## HISTORIC AND DESIGN REVIEW COMMISSION

December 06, 2017

**HDRC CASE NO:** 2017-611  
**ADDRESS:** 244 W CEVALLOS  
**LEGAL DESCRIPTION:** NCB 1011 BLK 1 LOT 13  
**ZONING:** O-1  
**CITY COUNCIL DIST.:** 1  
**APPLICANT:** Mike Sepeda/ADA Consulting Group Inc.  
**OWNER:** Key Properties  
**TYPE OF WORK:** Flatwork and installation of 8ft tall wrought iron fence  
**APPLICATION RECEIVED:** October 30, 2017  
**60-DAY REVIEW:** December 29, 2017  
**REQUEST:**

The applicant is requesting a Certificate of Appropriateness for approval to construct a surface parking lot at 244 W Cevallos, including the installation 8 foot tall wrought iron fence around the perimeter of the property.

View of 8 ft tall wrought iron fence w/ gate installed along Marty Street

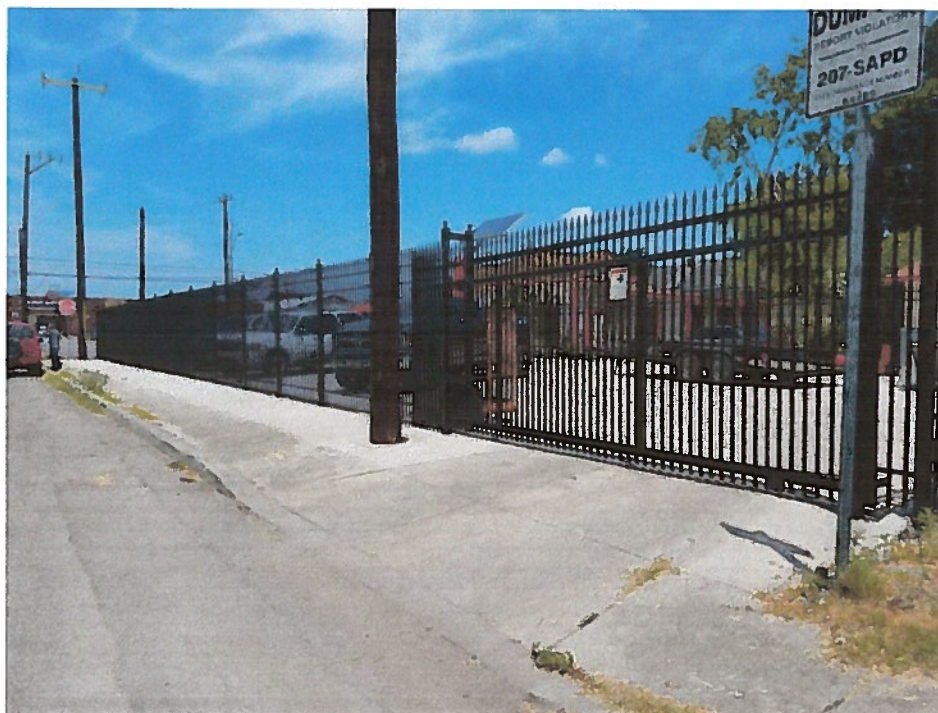
- f. FENCE – The applicant has proposed a black wrought iron fence that is to be eight (8) feet in height. Per the UDC 35-673(h)(1) noting the use of 2 to 4 feet low scale walls to divide space between properties and right-of-ways and the use of solid walls up to 6 feet walls screen equipment or unsightly areas -- staff finds a fence height of six (6) feet appropriate at this location.

Staff recommends approval with the stipulation that the overall height of the fence be reduced to 6 feet based on the findings.

SITE PLAN FOR FENCE AT  
244 W. CEVALLOS ST.  
8 ft tall wrought iron fence on all  
sides of Lot 13  
(50 ft x 138.88 ft rectangular lot)  
with gate at existing driveways  
on W. Cevallos & Marty Streets

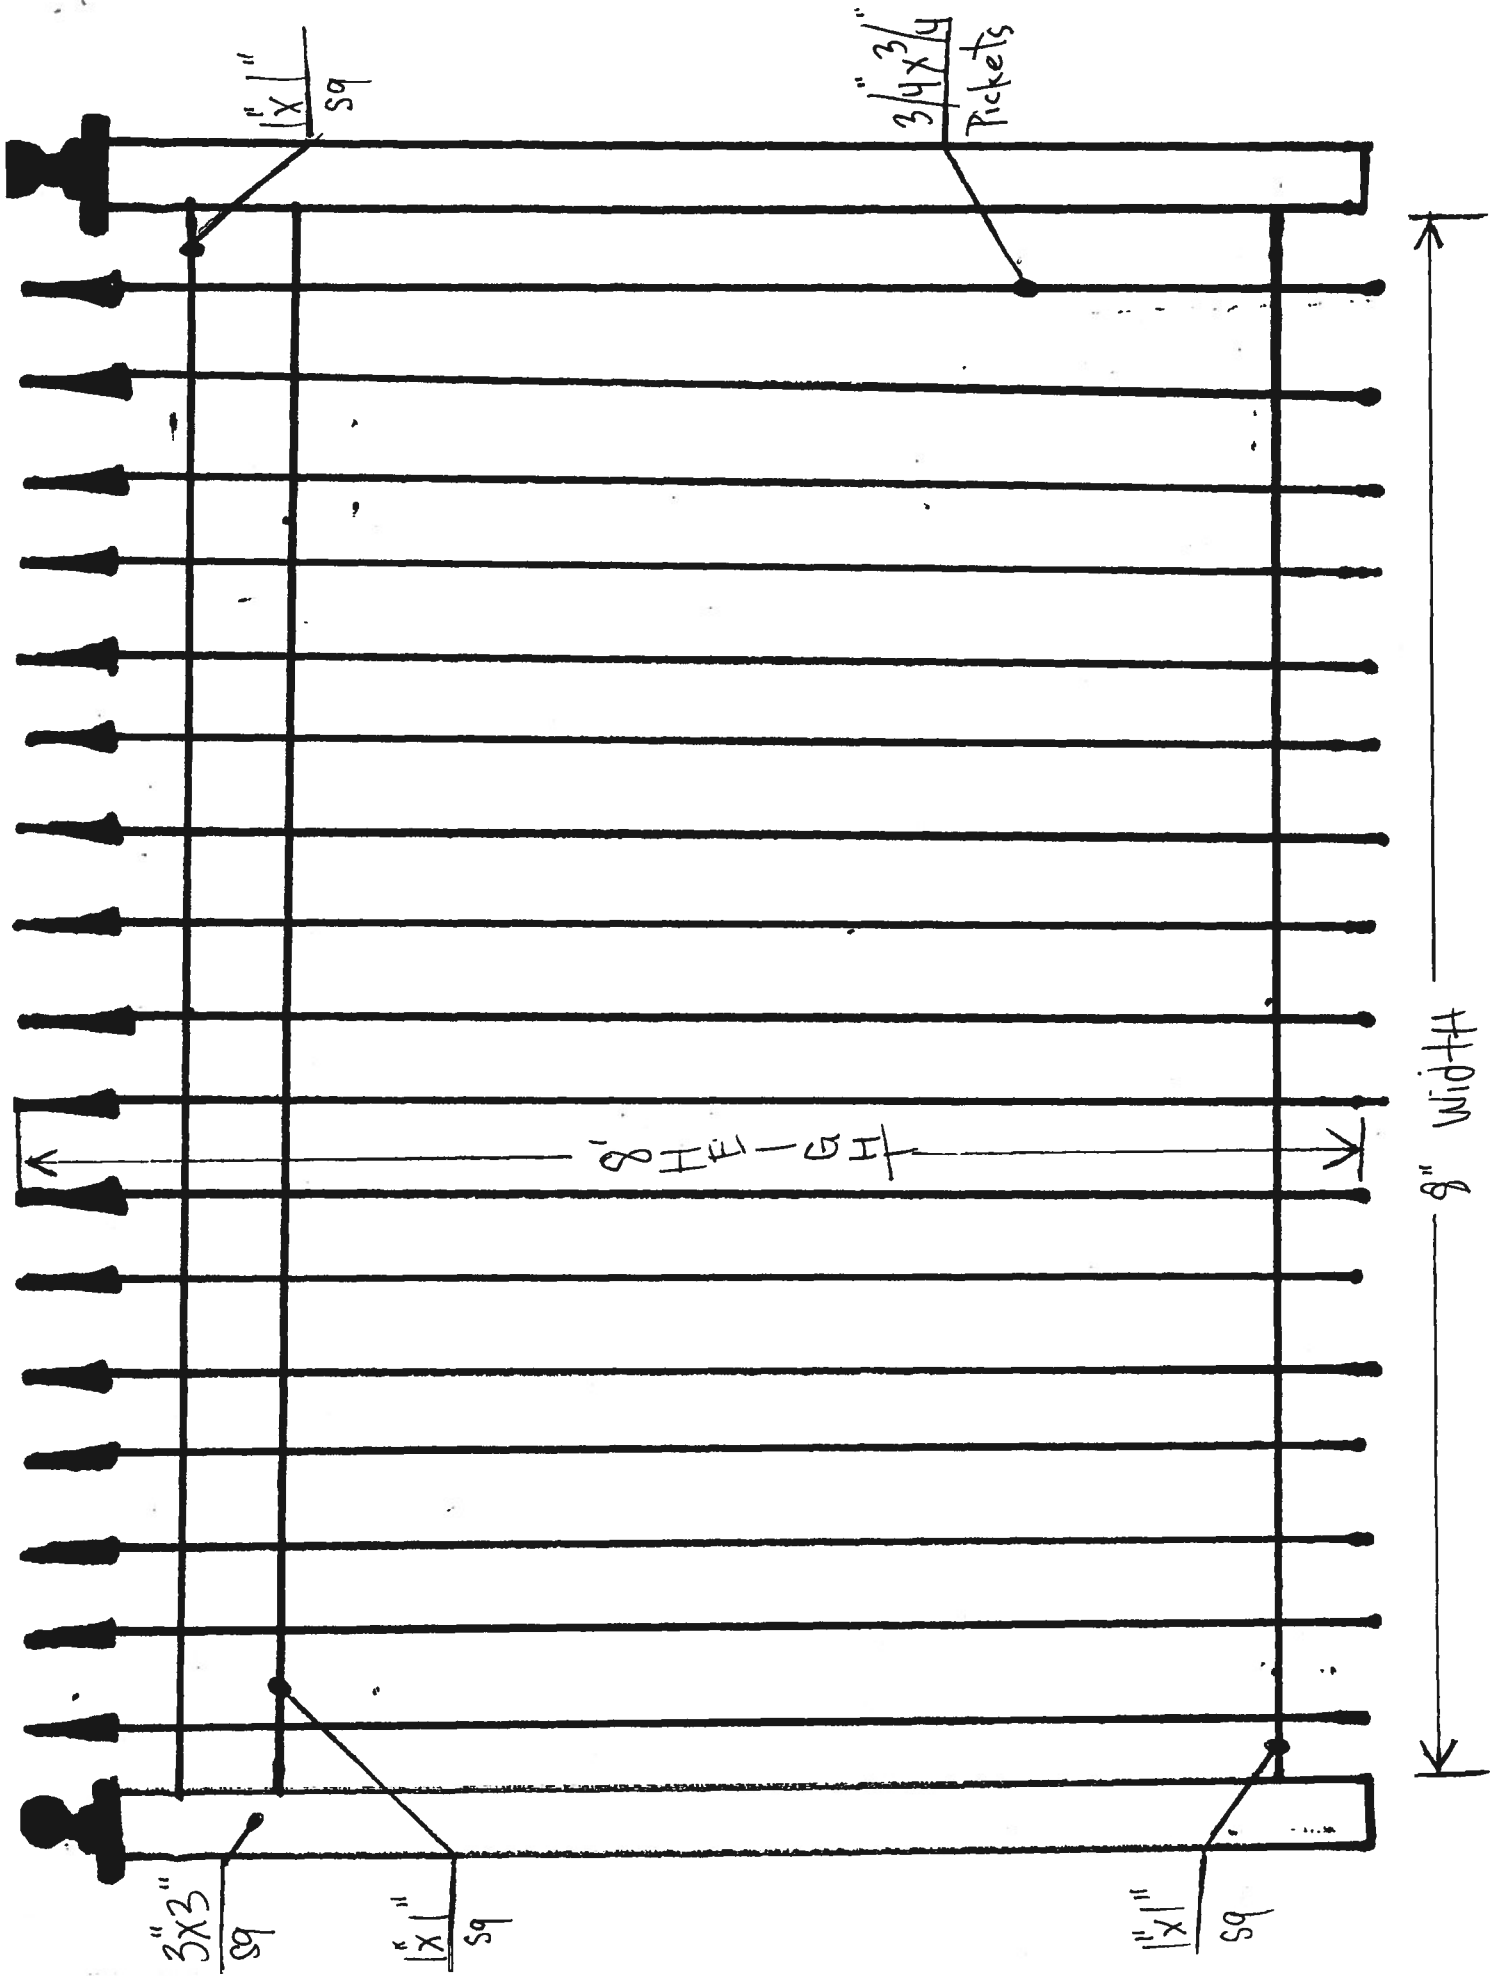
- e. CURB CUTS – The applicant has proposed two curb cuts with gated entry to facilitate automobile entry into the parking lot. These curb cuts and corresponding entry is to be located on Marty and W Cevallos , at the interior of the site, removed from major automobile and pedestrian thoroughfares. The UDC notes that a width of twenty-five (25) should not be exceeded for curb cuts. Staff finds the proposed curb cut locations to be appropriate and consistent with the UDC.
